**Addendum # 002**

**TENDER NUMBER: 619-CP2003**

**Renovations and Atrium Project**

**Our Lady of Fatima Catholic School**

DATE PLOTTED 2020-03-05 3:38:27 PM	DRAWN BY PC	DRAWING No.
SCALE As indicated	CHECKED BY RW	<b>A120</b>
PROJECT No.	1901

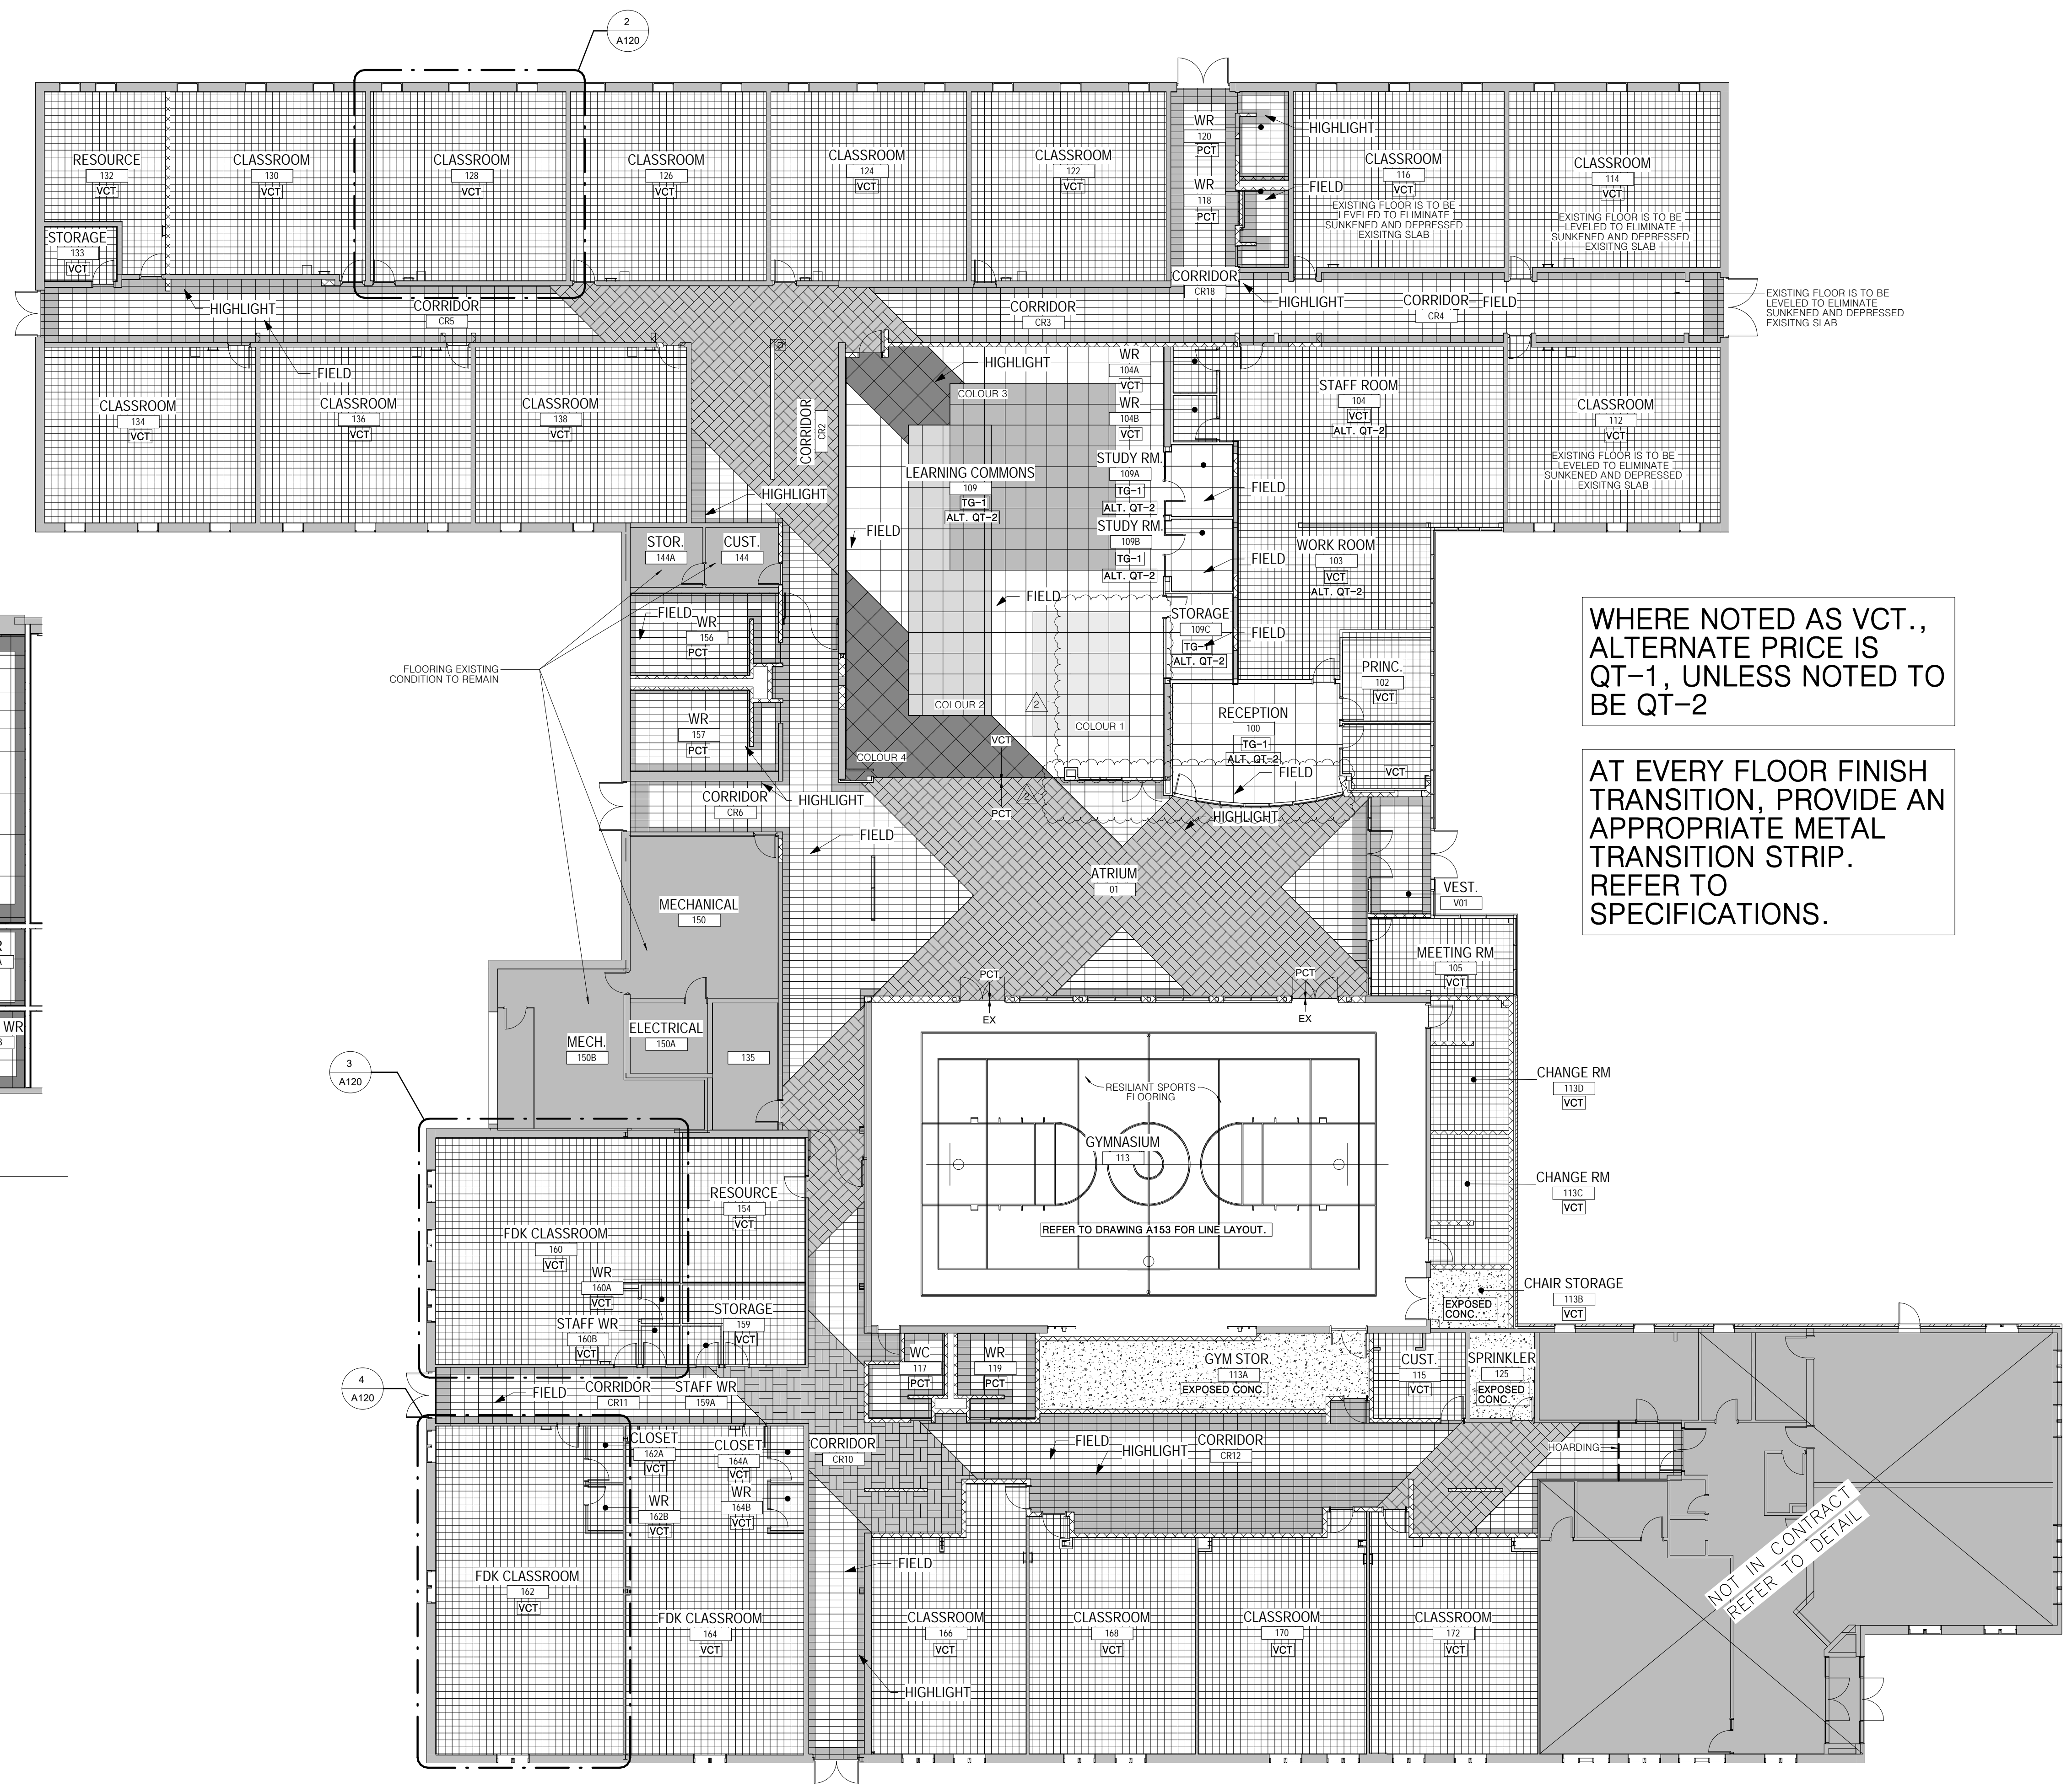
- Q8: The Room Finish Schedule (A1001) lists Room 101 as "Conference," but there is no Room 101 on dwg A100. Please clarify.
- A8: There is no Room 101. Refer to updated drawing set issued with this addendum.

DATE PLOTTED 2020-03-05 3:40:06 PM	DRAWN BY PKC	DRAWING No. A175
SCALE As indicated	CHECKED BY RW	
PROJECT No. 1901

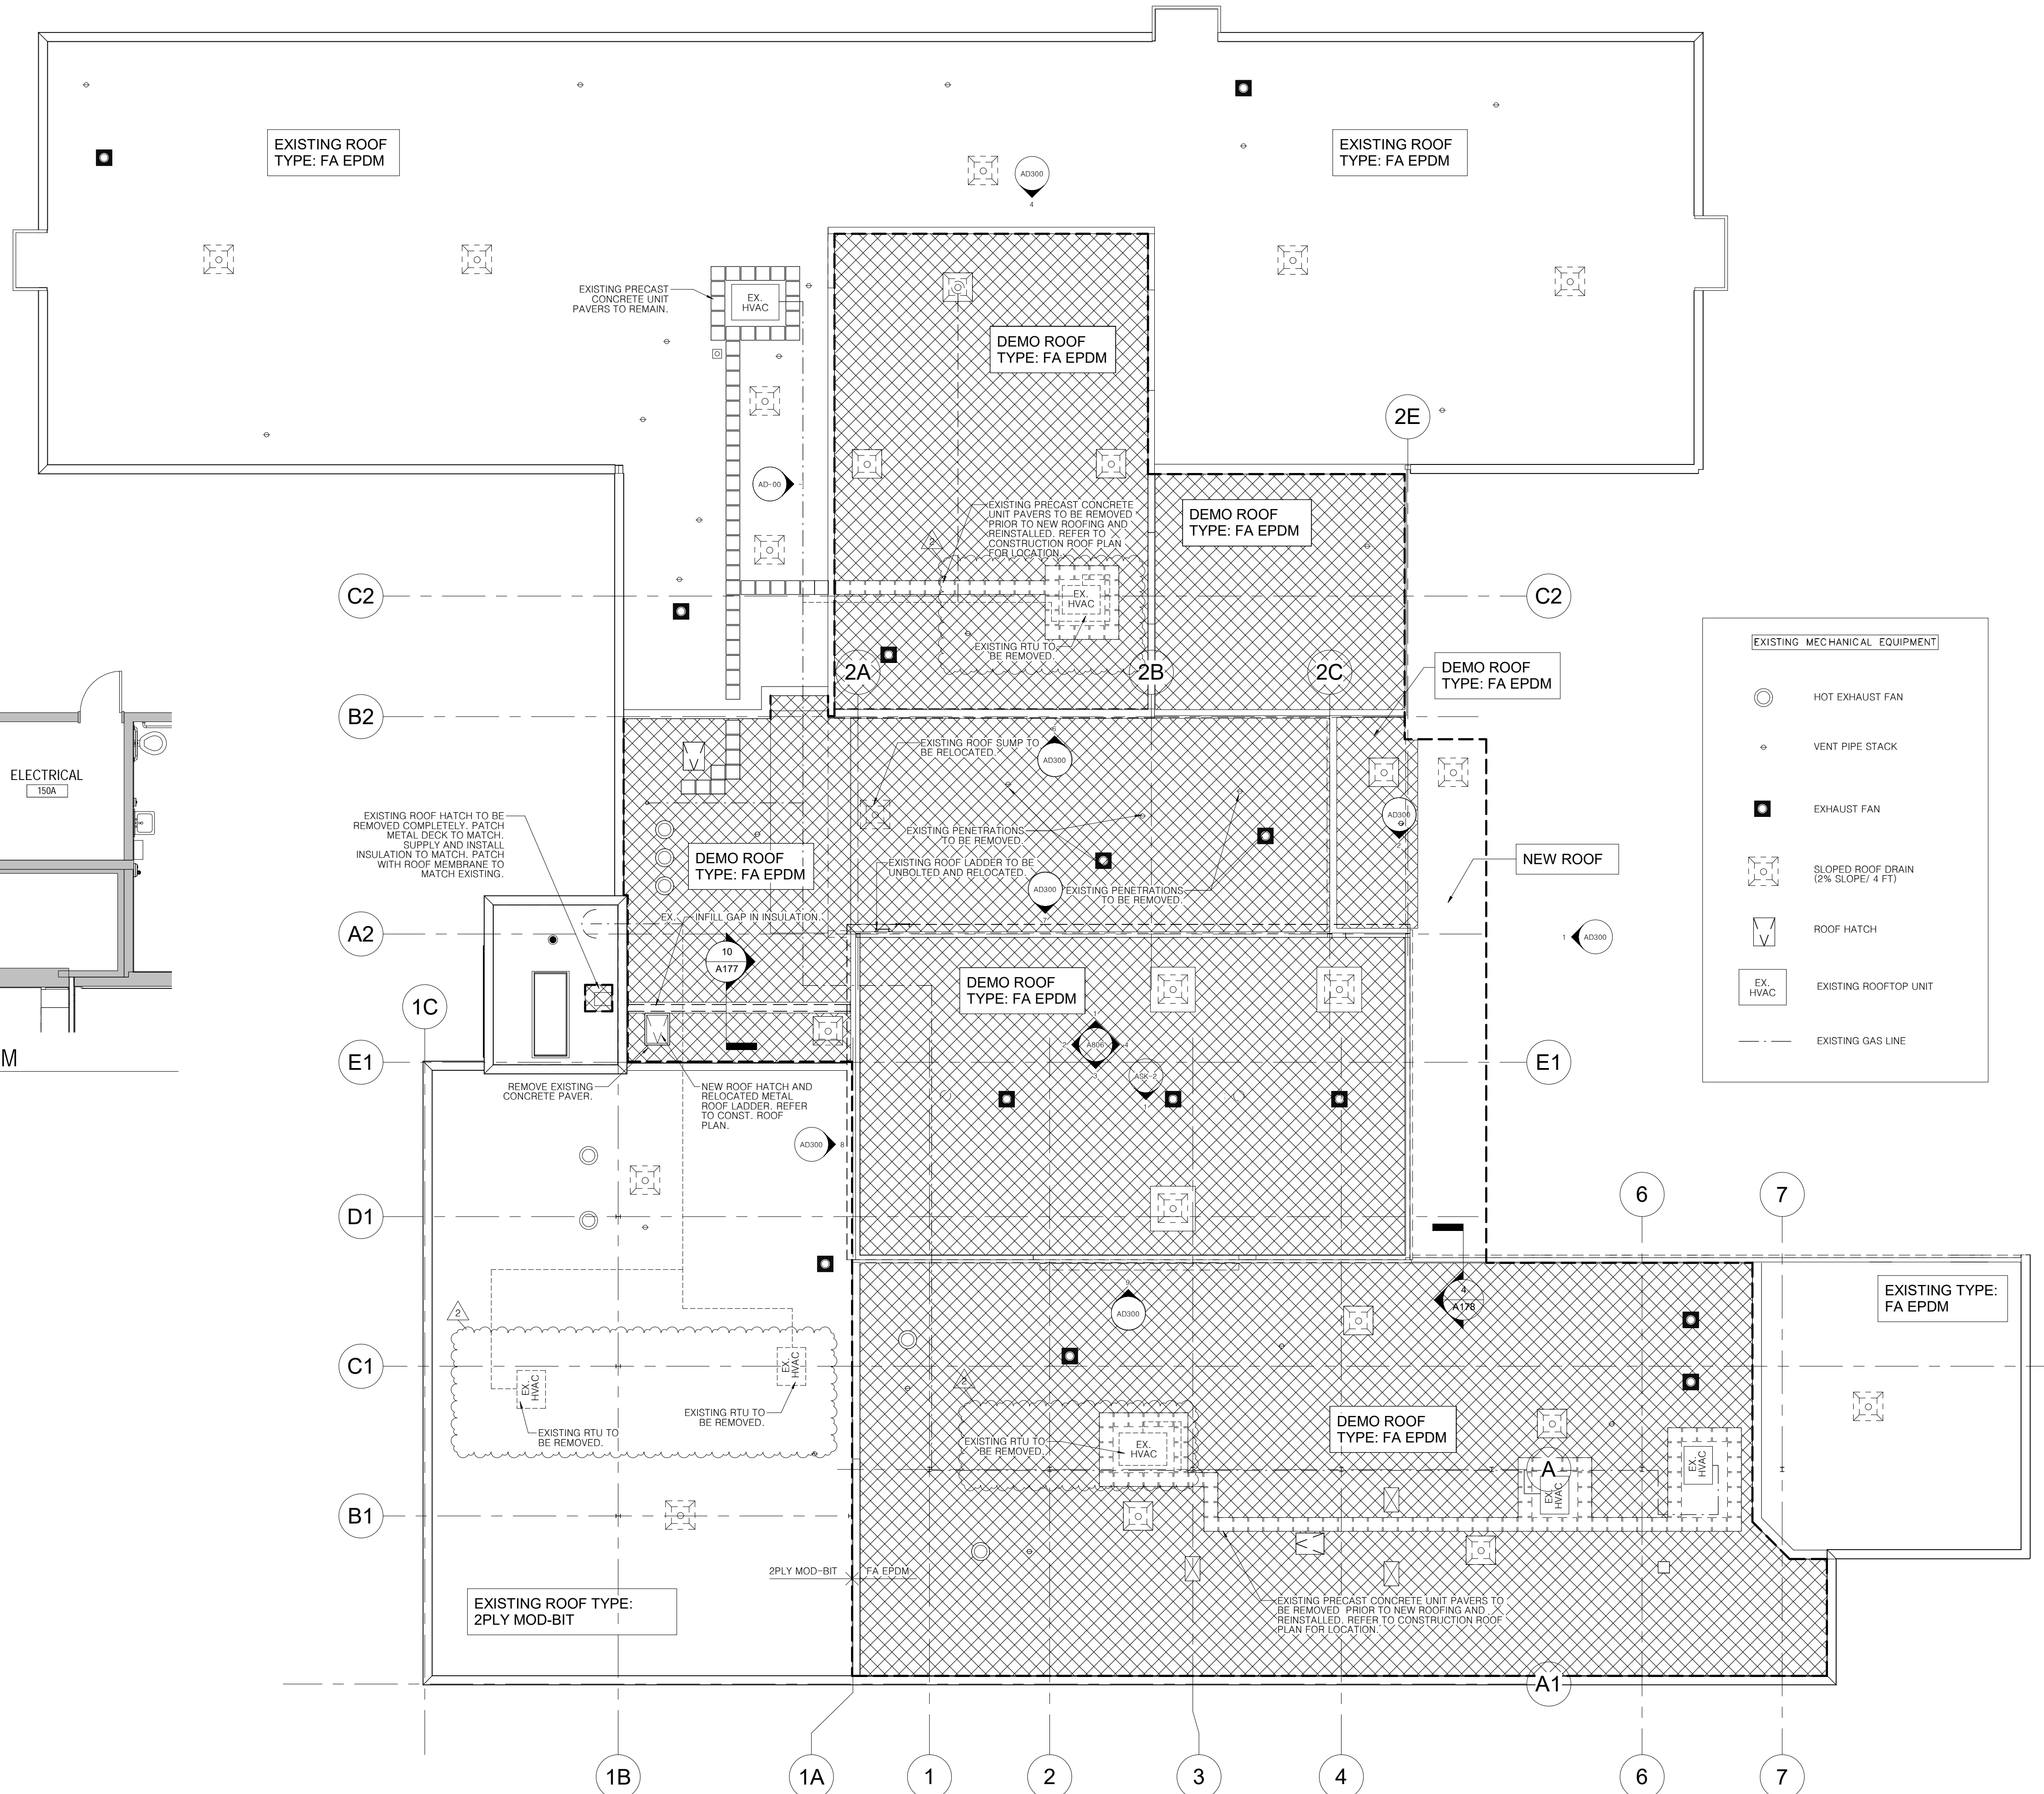
- A12: Roofers do not need to be members of either CRCA/ORCA to bid to this project. They will have to comply to the specification requirements.
- Q13: Architectural drawing A175 indicates that tapered roof insulation is required at roof perimeters. What material and slope is required? This is not called off in the project specifications.

- A13: Refer to revised drawing sets issued as part of this Addendum. There is no longer a requirement for tapered roof insulation.
- Q14: Would you consider adding our primerless AVB and VP membranes for Section 07 26 00 Vapour and Air Barrier Membrane?
